Access Compliance Report

Public Rights-of-Way

Intersection ID: 15457	Main Street: EAST_BV	Cross Street: LOMBARDY_CR	Location: W
ADA ID: CF133F1EC469	Ramp Type: Perp	Initial Pass/Fail: Fail	Overall Compliance: No
		Severity Score: 25

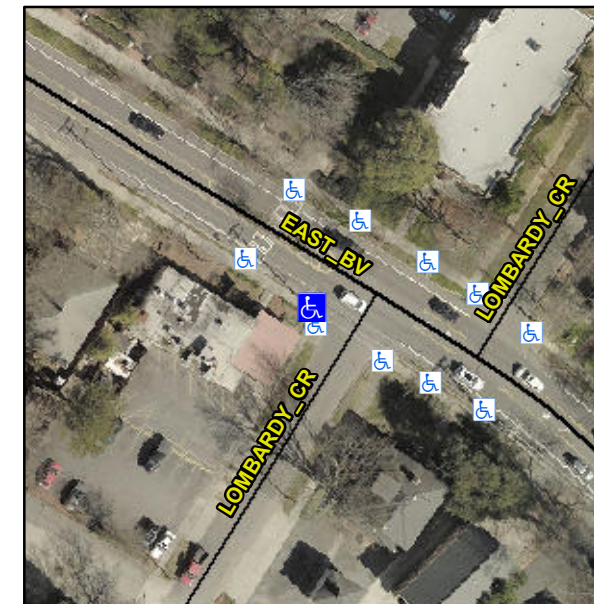
Not Found, R304.2.2, R304.5.3

Compliance	Description	Data	Compliance	Description	Data
N/A	Ramp Length (in)	59.0	No	Ramp Slope (%)	10.3
Yes	Ramp Width (in)	48.0	No	Ramp XSlope (%)	6.3
N/A	Flare Type LT	N/A	N/A	Flare Type RT	N/A
N/A	Flare Slope LT (%)	N/A	N/A	Flare Slope RT (%)	N/A
N/A	Flare Traversable LT?	N/A	N/A	Flare Traversable RT?	N/A
N/A	Landing Length (in)	N/A	N/A	DWS Provided?	N/A
N/A	Landing Width (in)	N/A	N/A	DWS Contrast?	N/A
N/A	Landing Slope (%)	N/A	N/A	DWS Length (in)	N/A
N/A	Landing X Slope (%)	N/A	N/A	DWS Full Width?	N/A
N/A	Landing Curb? (Y/N)	N/A	N/A	DWS Offset (in)	N/A
N/A	Shared Landing?	N/A			
N/A	Gutter Ponding?	N/A	N/A	Gutter Slope (%)	N/A
N/A	Gutter Lip Ht (in)	N/A	N/A	Gutter X Slope (%)	N/A
N/A	Painted X Walk1?	No	N/A	Painted X Walk2?	N/A
	X Walk 1 Direction	To NE		X Walk 2 Direction	N/A
N/A	X Walk 1 Width (in)	N/A	N/A	X Walk 2 Width (in)	N/A
	X Walk 1 Slope (%)	5.3		X Walk 2 Slope (%)	N/A
	X Walk 1 X Slope (%)	4.4		X Walk 2 X Slope (%)	N/A

Remove & Replace Entire Ramp.
